UN Regulation No. 92 (Replacement Exhaust Silencing Systems for Motorcycles)

Proposal for a Supplement 1 to the 02 series of amendments to UN Regulation No. 92

**Submitted by the experts from Germany, the Kingdom of the
Netherlands, Switzerland, the United Kingdom of Great Britain and
Northern Ireland and the European Commission***

Figure 1: Exhaust silencer

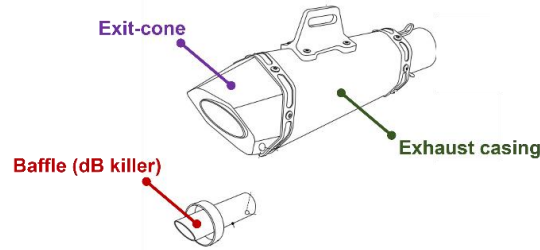
"2.8. **“Exit-cone”** means the final part of the exhaust silencing system outlet through which exhaust gases exit into the air (see figure 1).
